591, 593 COBBITTY ROAD &
1 FRESHWATER DRIVE, COBBITTY
(PRECINCT 2A STAGE 1 &
TRANCHE 5a STAGE 1)
ROAD & DRAINAGE DESIGN

ISSUED FOR SUBDIVISION WORKS CERTIFICATE

WORKS AS EXECUTED
WORKS AS EXECUTED INFORMATION SHOWN IN RED.
DATE: 15/09/2025

KERB RETURN PLAN - KR 59 & KR 60
SCALE 1:200

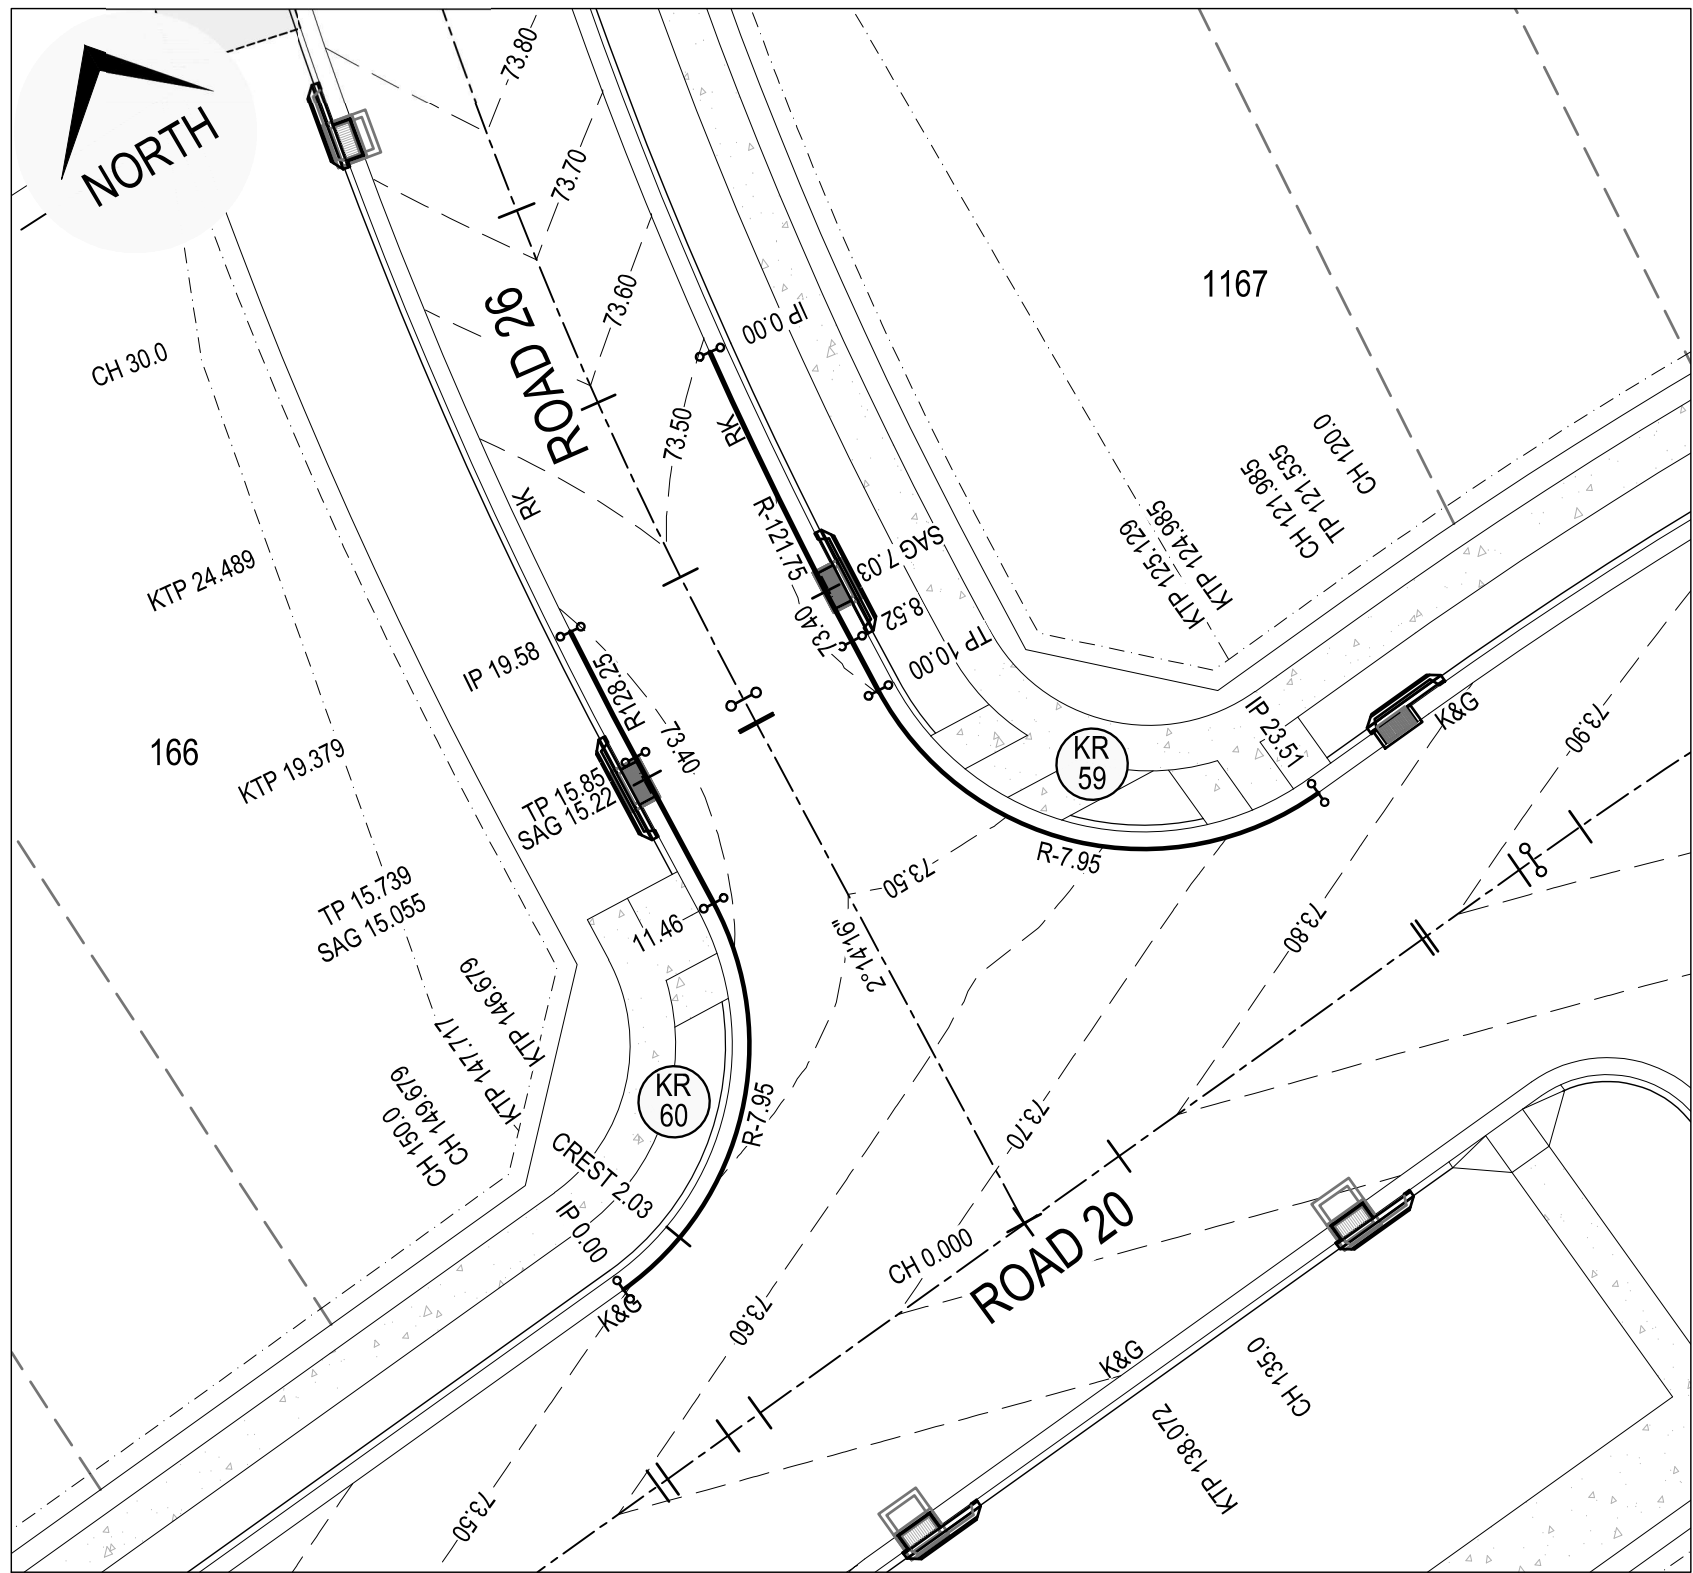
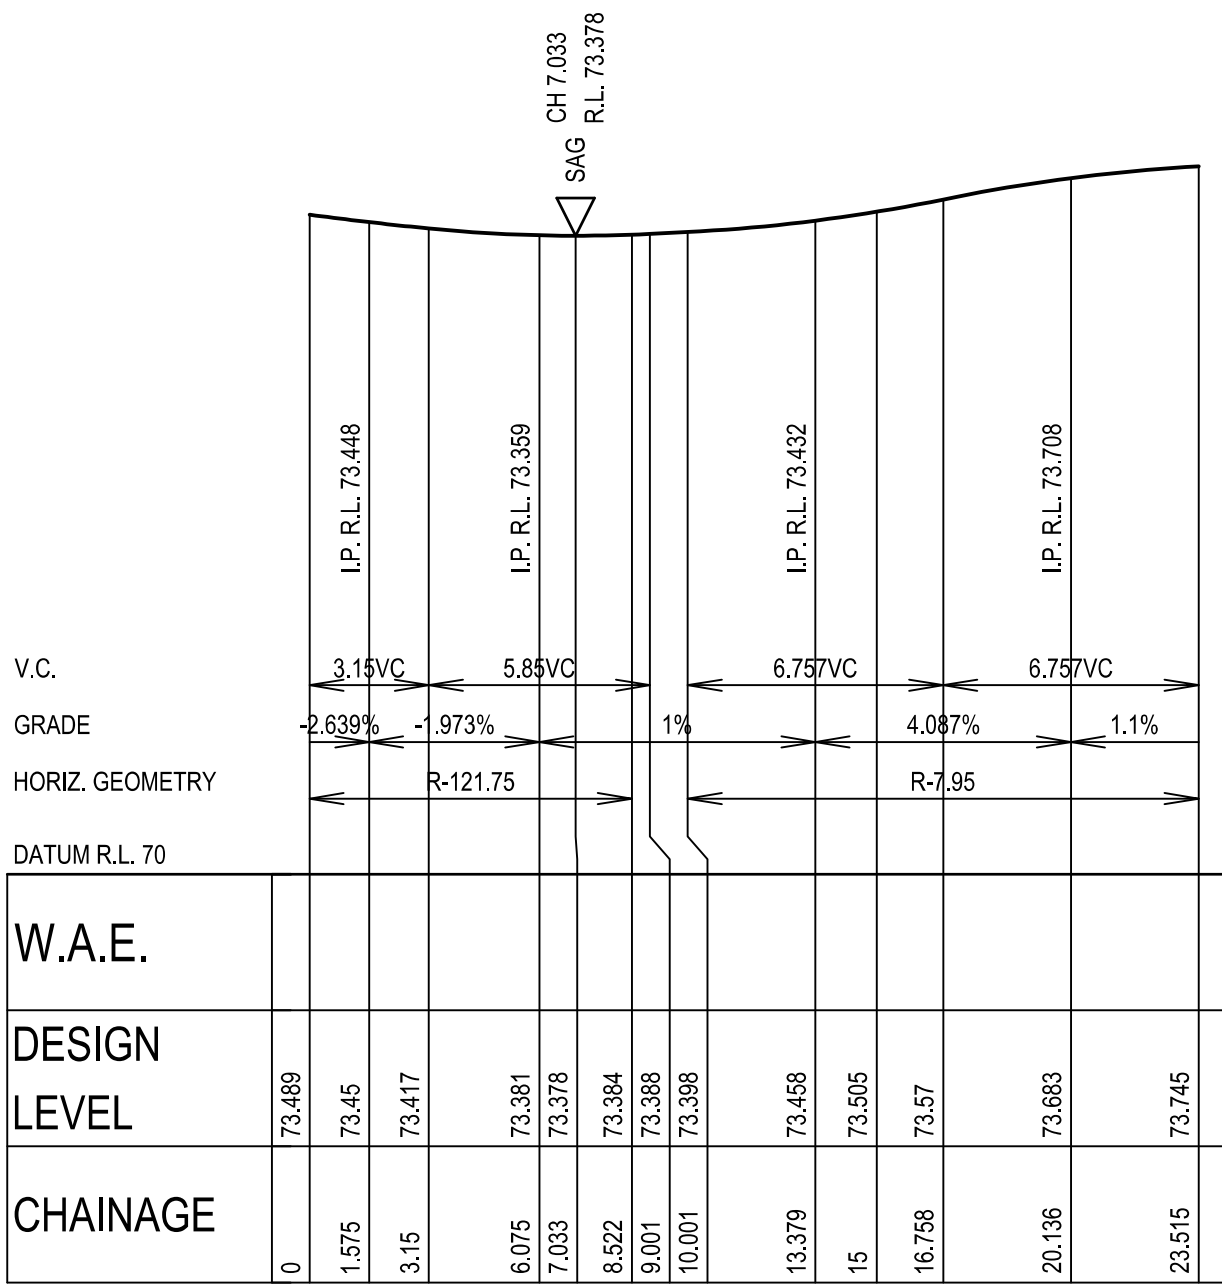
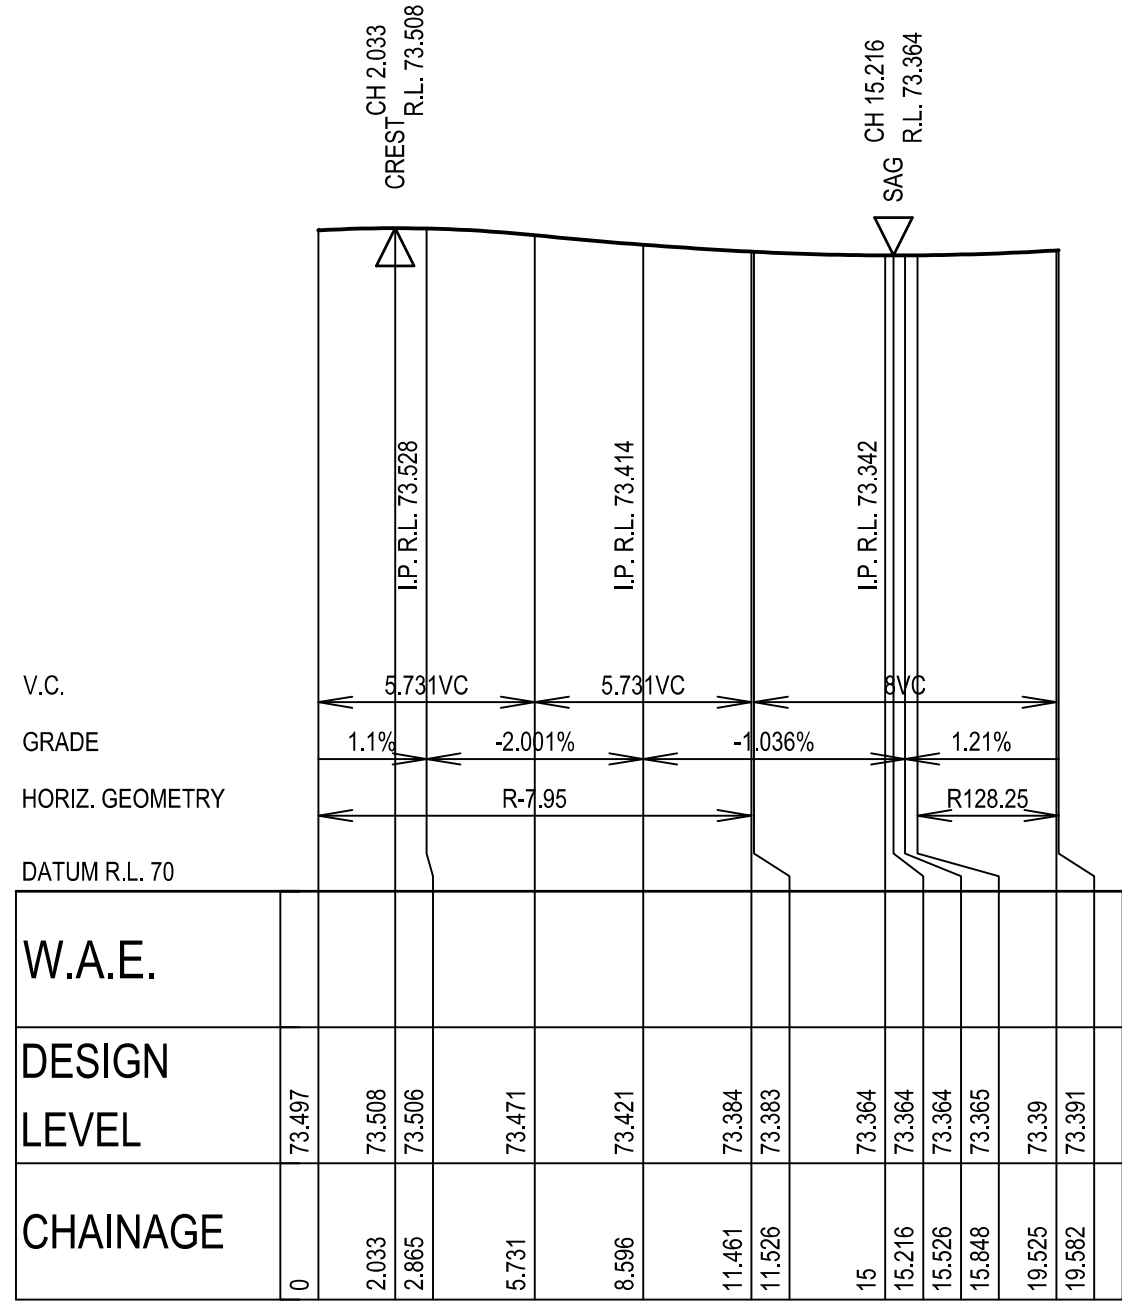
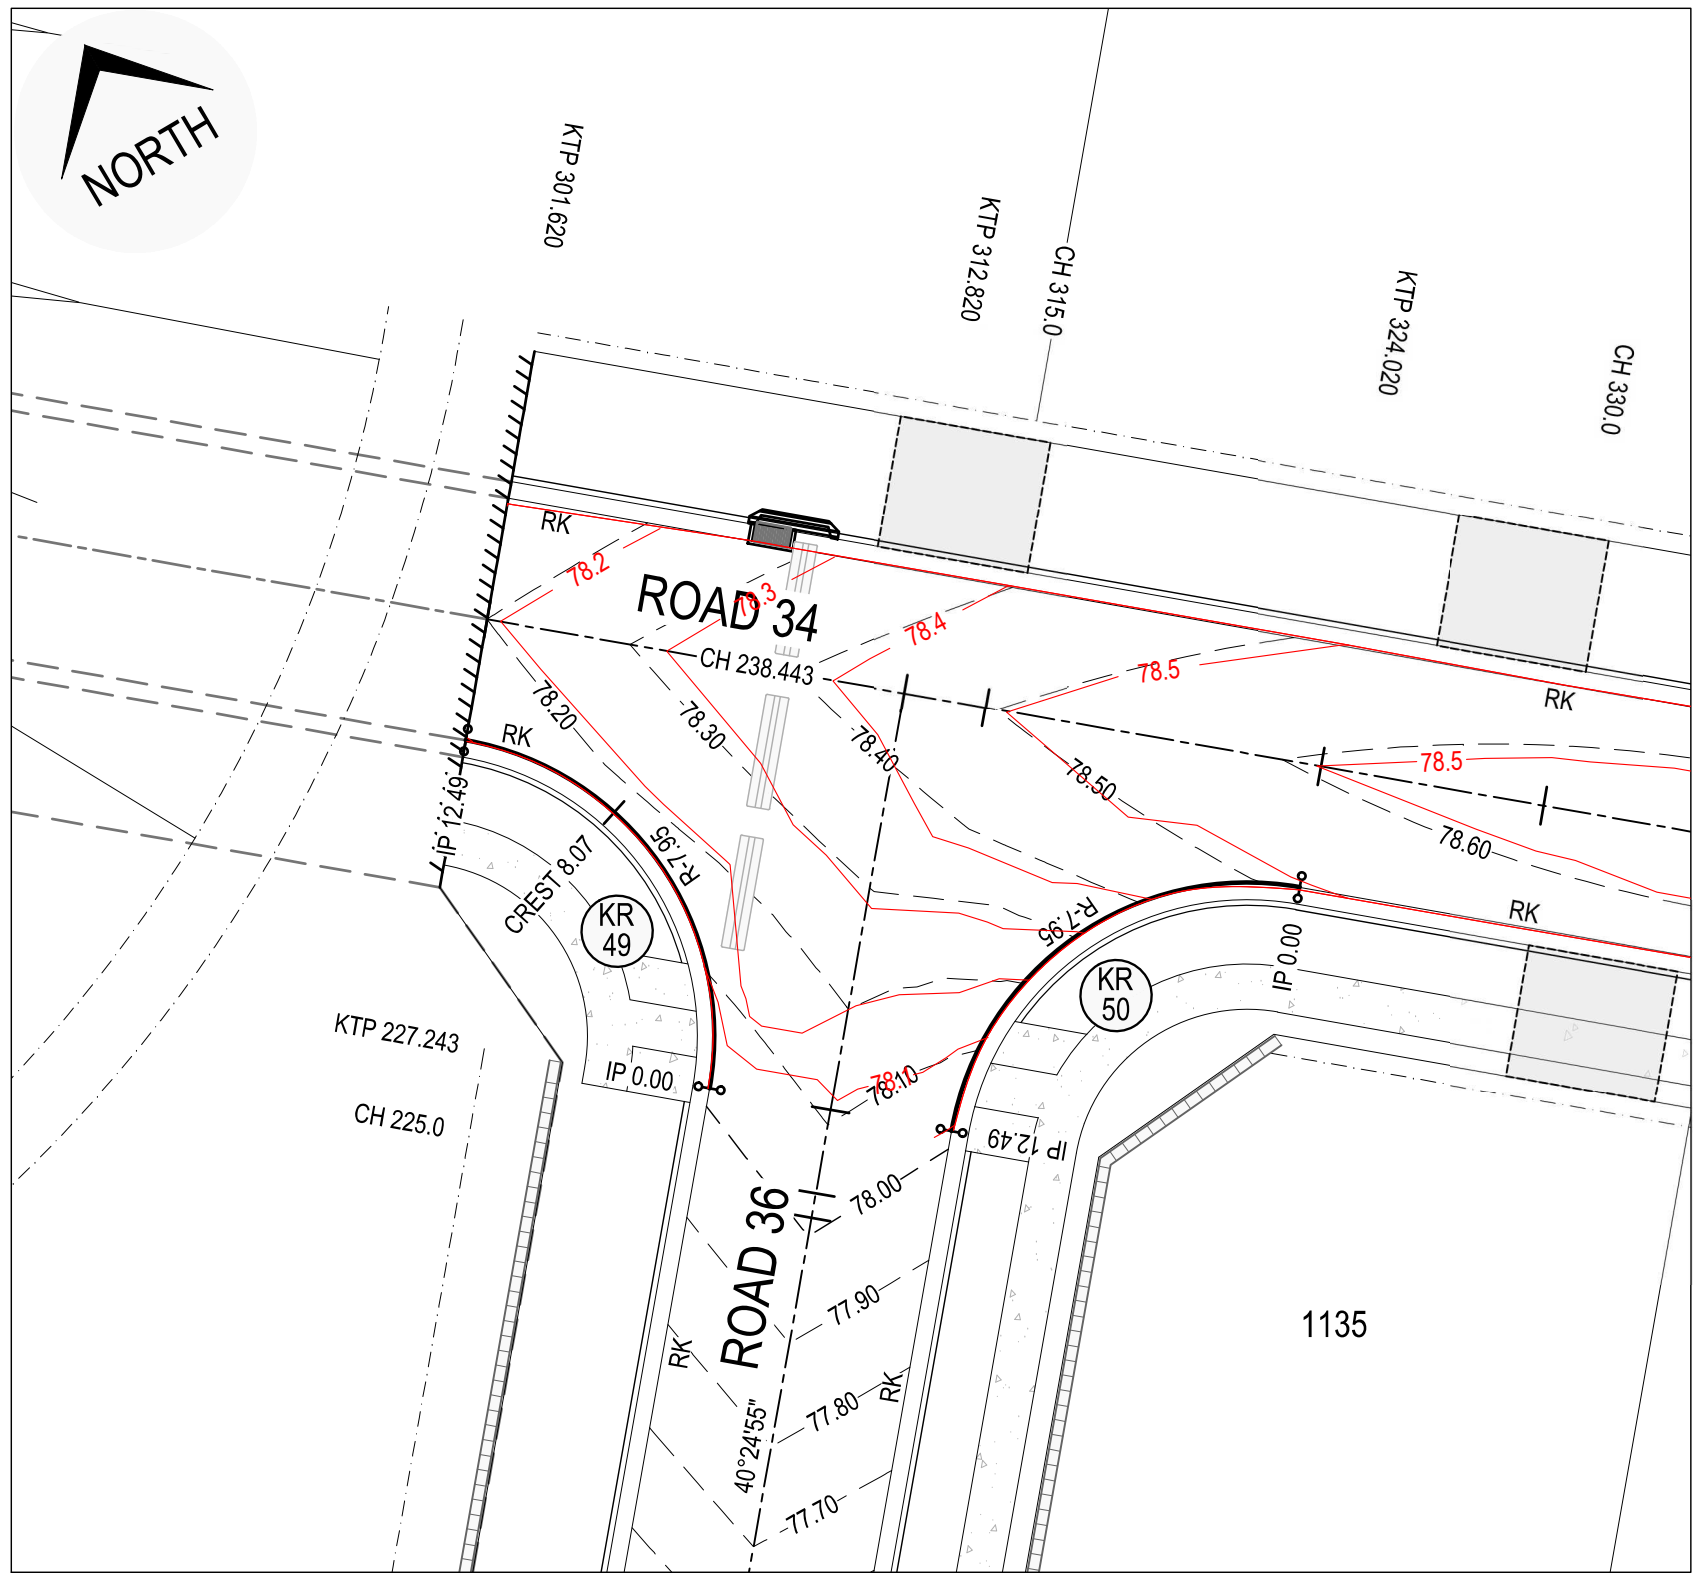
*ROAD 20 KG AMENDED
*PRAM RAMP CHANGED TO SQUARE WINGS
